HYDROLOGY K15/D30A ONE PLAN

REF: DRAINAGE PLAN FOR ALBUQUERQUE CARDIOVASCULAR BUILDING (K15-D30A)
RECEIVED SEPTEMBER 11, 1985

RE: DRAINAGE PLAN FOR ALBUQUERQUE CARDIOVASCULAR BUILDING
(K15-D30A)

REF: REVISED DRAINAGE PLAN FOR ALBUQUERQUE CARDIOVASCULAR BUILDING (K15-D30A) REVISION DATED 10/9/85

TITLE: SIDEWALK CULVERTS
1001 COAL AVE. S.E.

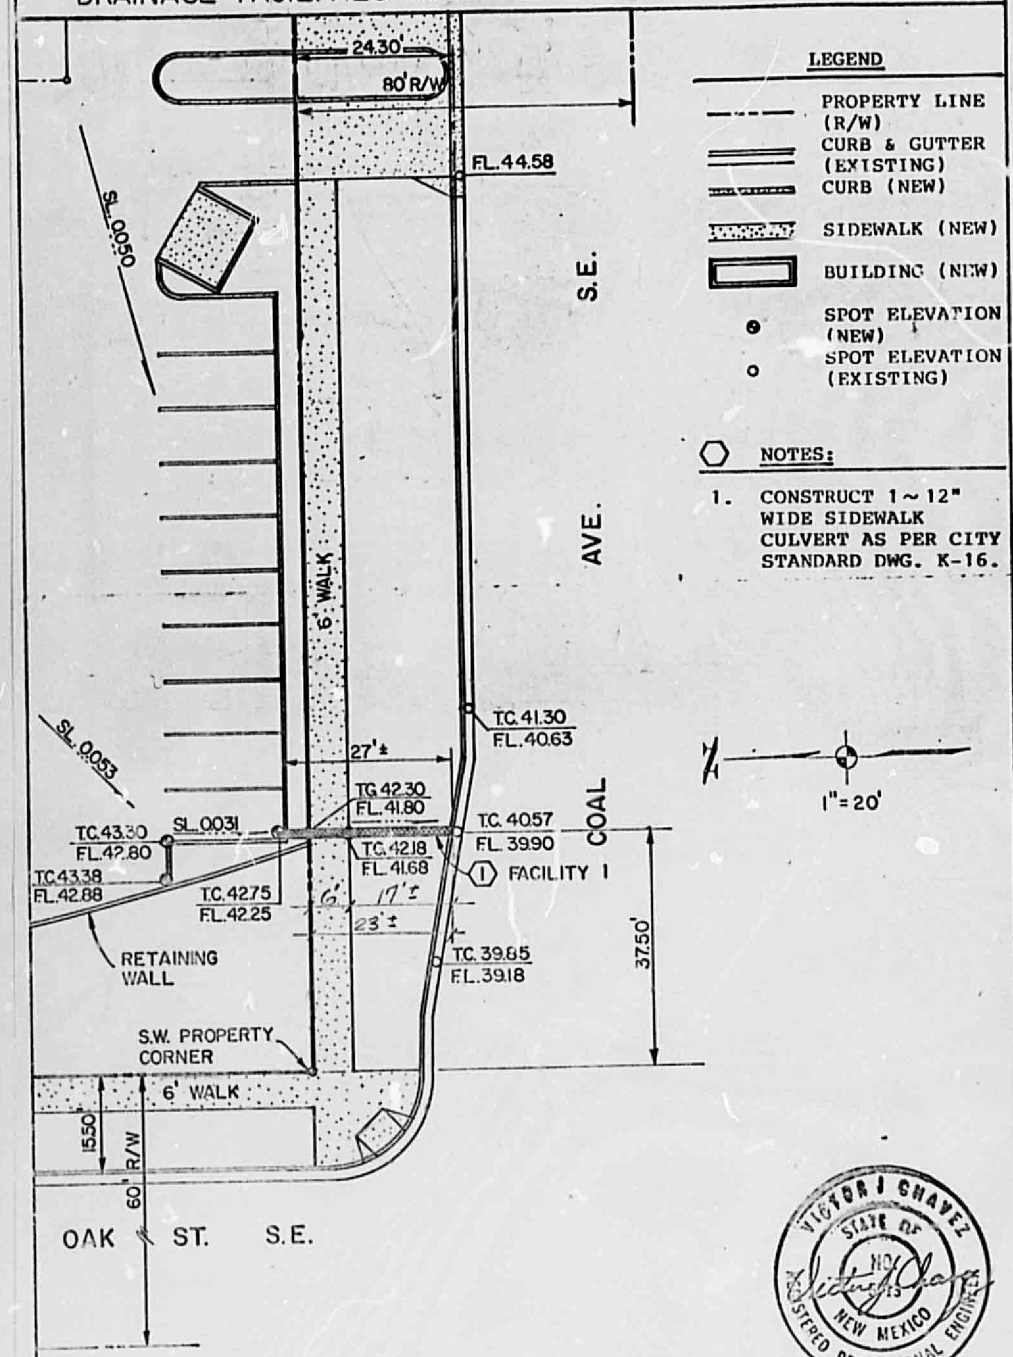
4. Quanitification of off-site flows. In adding the off-site flows to the developed flows will the proposed 12" sidewalk culvert be able to handle the flows?

4. Off-site flows (to the sidewalk culvert southeast of the proposed building).

$Q = CiA$
$C = 0.71$
$i = 5.06$ in./hr.
$A = 2.12$ acres
$Q(100) = (0.71)(5.06)(2.12) = 7.62$ cfs

Capacity of 12" sidewalk culvert:

$Q = 1.486\ A^{5/3}\ S^{1/2} / n\ p^{2/3}$
$A = 0.5$ s.f.
$P = 2.0$ ft.
$n = 0.013$
$s = 0.13$

$Q = (1.486)(0.5)^{5/3}\ (0.13)^{1/2} / (0.013)(2.0)^{2/3}$
$= 8.18$ cfs. > 7.62 cfs.

PIPE DRAIN SECTION (FACILITY 2)

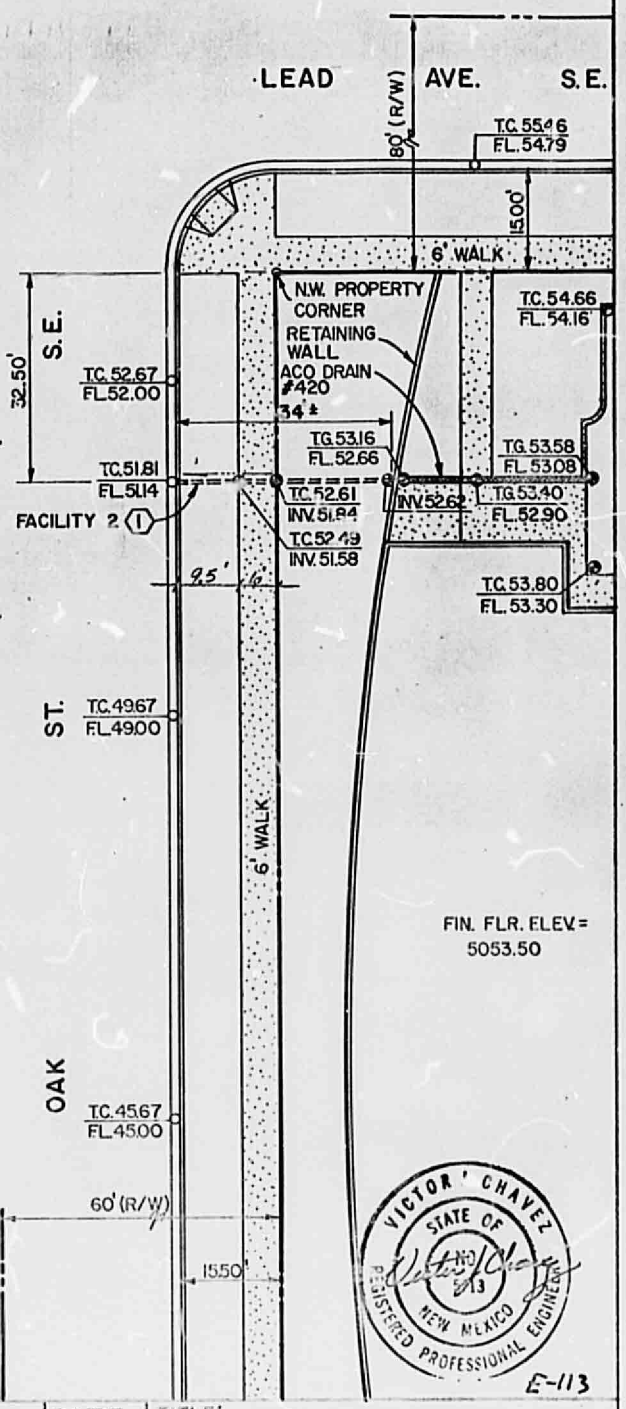
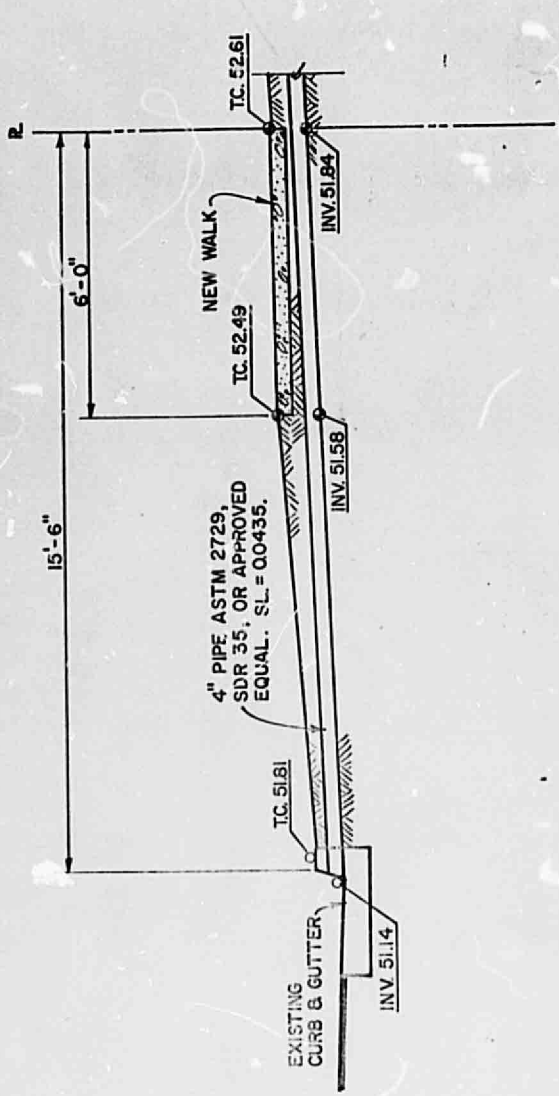
5. Internal contributary drainage areas, outlined on plan. Please indicate what flow will outlet through the drivepads, sidewalk culvert and the 4" pipe.

5. Runoff to 4" pipe:

$Q = CiA$
$C = 0.88$
$i = 5.06$
$A = 0.10$ acres
$Q = (0.88)(5.06)(0.10) = 0.45$ cfs.

Capacity of 4" pipe:

$Q = 0.463(d)^{8/3} S^{1/2}/n$
$d = 0.33$ ft.
$s = 0.0435$
$n = 0.011$

$Q = 0.463\ (0.33)^{8/3}\ (0.0435)^{1/2}/0.011$
$= 0.46$ cfs.
